Amendments to the Drawings:

**REMARKS**

Annotated Drawings  
marked to show changes  
made

Fig. 1A

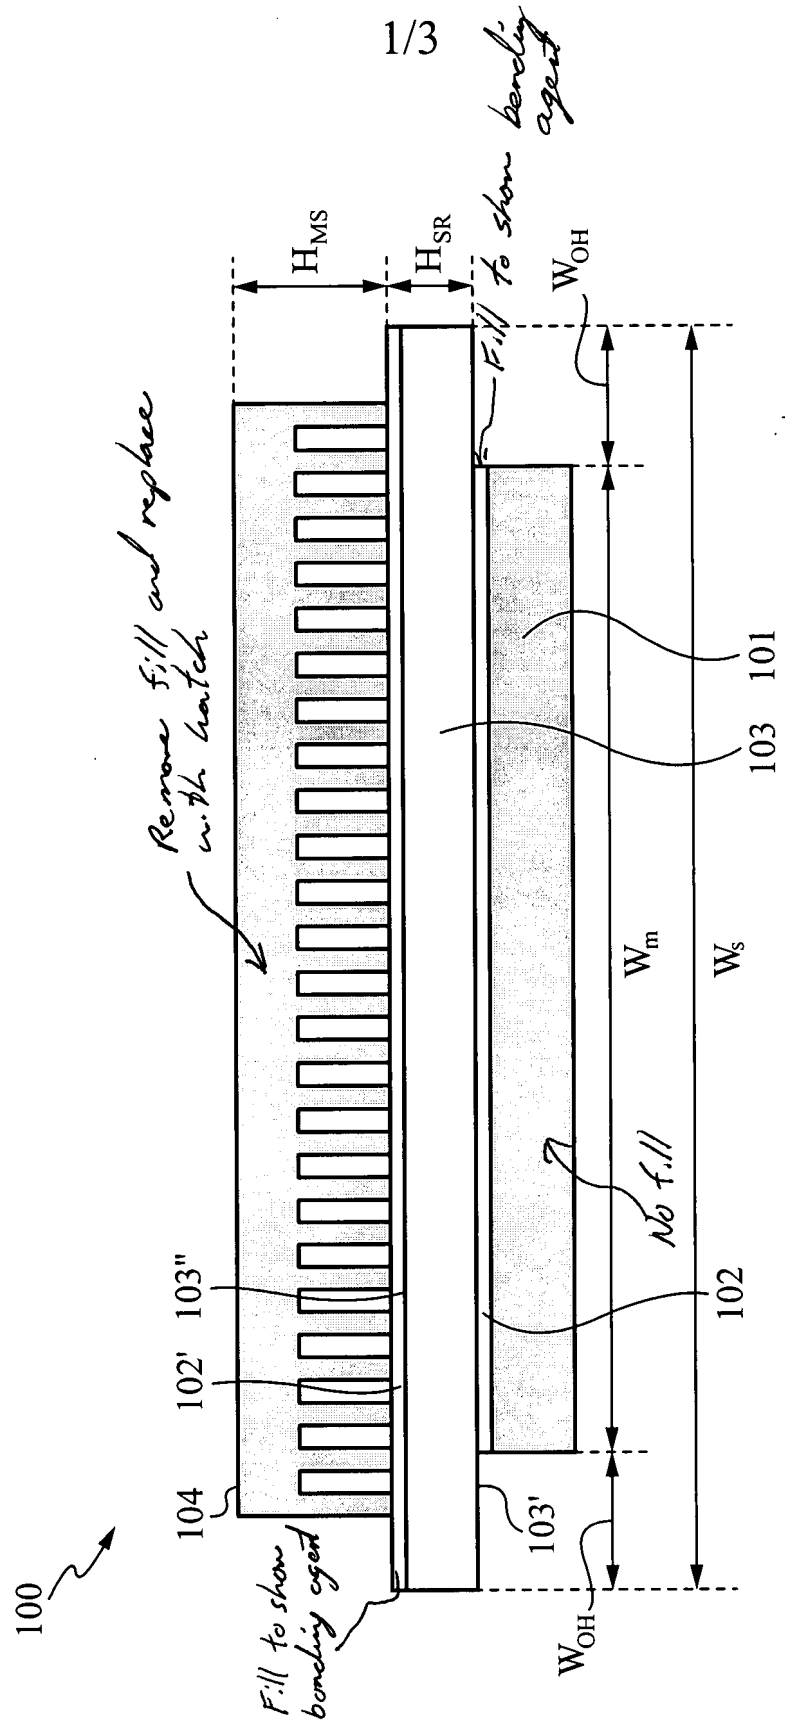
In Figure 1A, the gray shading of element 101 and 104 is replaced with crosshatching, the element of 103 is filled with crosshatching, and the bonding elements 102 and 102' is filed with the fill pattern for an adhesive or other bonding material.

The drawings have been objected to because they contain unevenly/improperly shaded areas ( elements 101 and 104 in Figure 1A; elements 201 and 204 in Figure 2; elements 302 and 303 in Figure 3A; elements 301 and 302 in Figure 3B). By way of the annotated and replacement drawings, the drawings are now in compliance and the submitted replacement sheets and annotated sheets are in compliance with 37 C.F.R. 1.121(d).

*Fig. 1B*

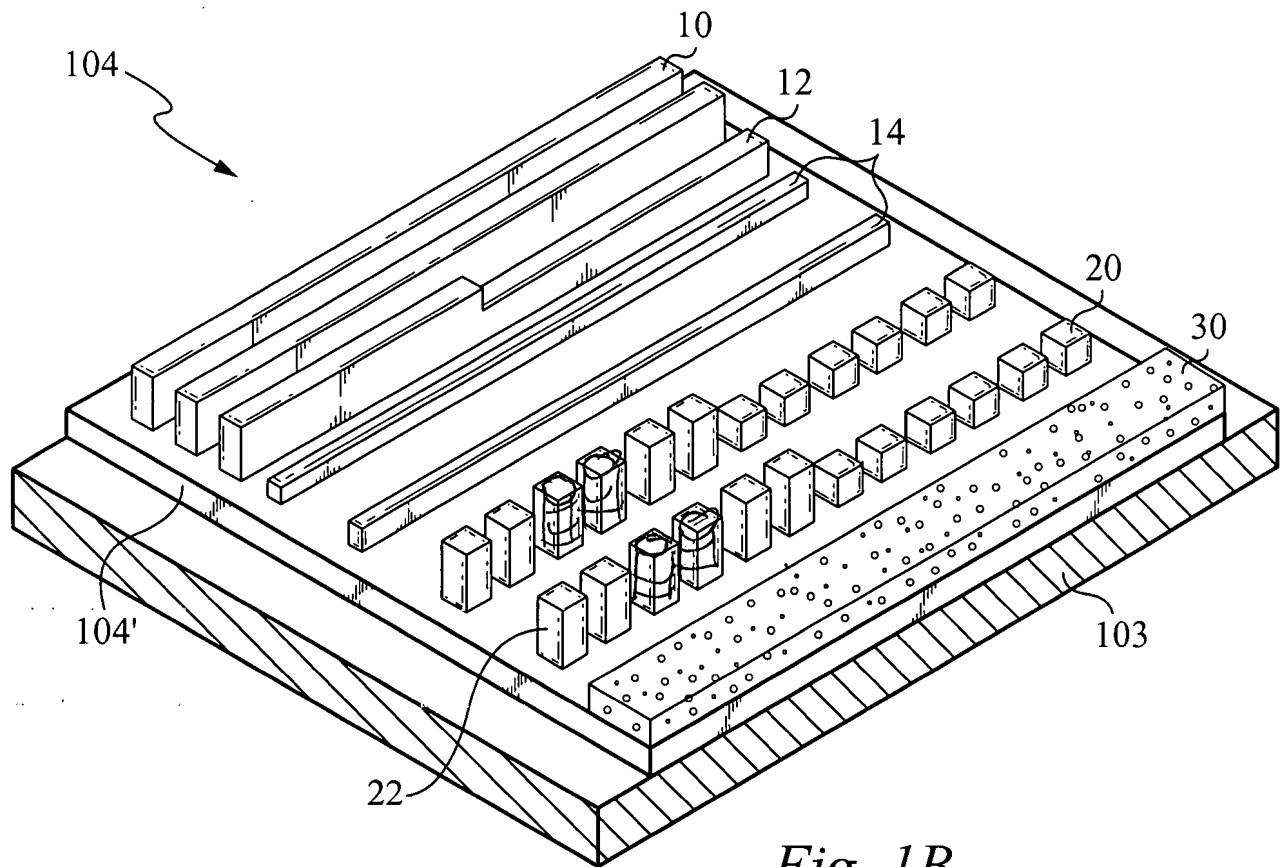
In Figure 1B, the micro pillars shown a element 22 is modified to show a micro pillar in the shape of a micro-pin.

The micropillars as called out in Claims 13, 17, 60 through 64 are disclosed in replacement sheet 2, Figure 1B, elements 20 and 22. These elements are supported in the specification on page 9, lines 5-13.

The micropillars comprising a plurality of pins as called out in Claims 14-16, 61-63, and 106-108 are disclosed in replacement sheet 2, Figure 1B, element 20. These elements are supported in the specification on page 9, lines 13-14.

*Fig. 2*

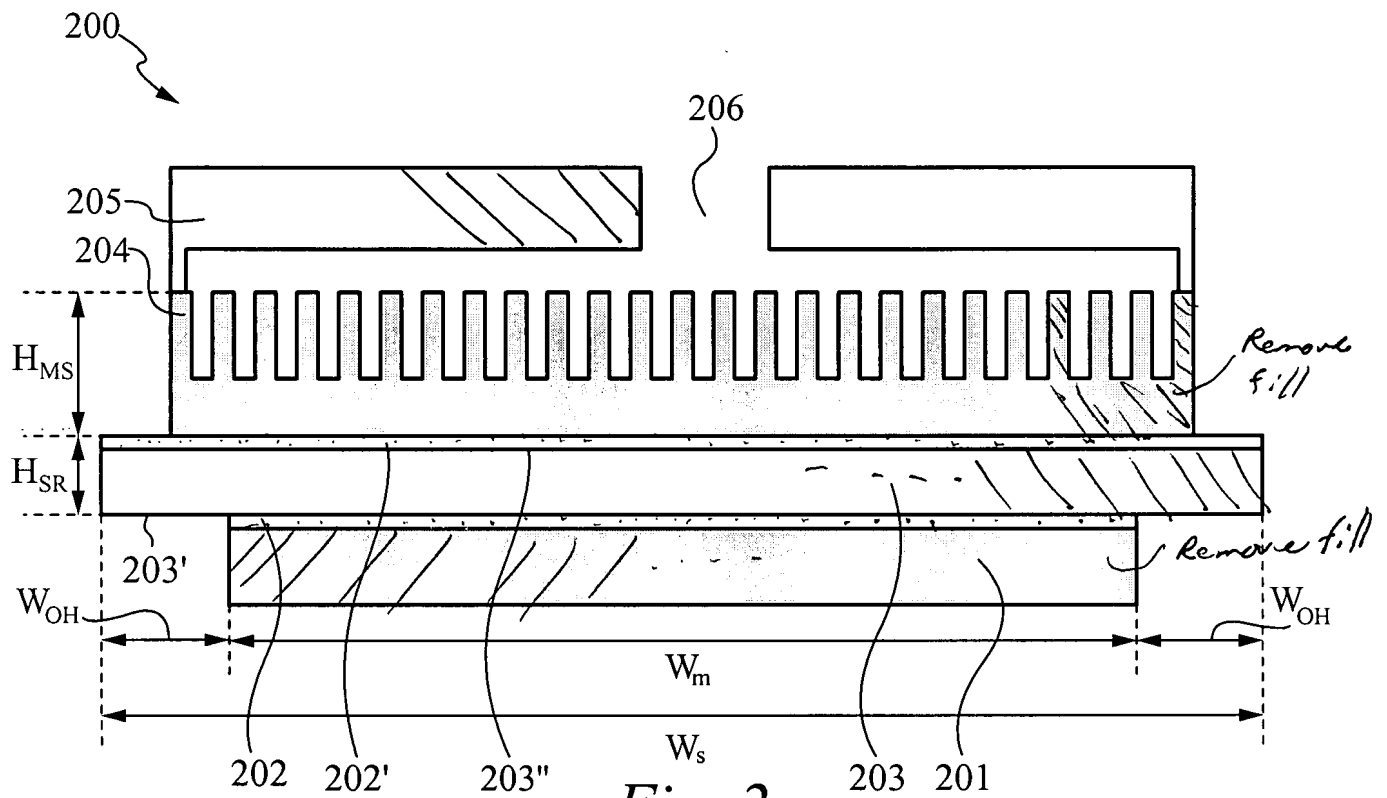
In Figure 2, the gray fill of 201 and 204 are replaced with a crosshatch pattern, the elements 203 and 205 are filled with crosshatch, and bonding elements 202 and 202' are filled with a fill pattern for an adhesive or other bonding material.
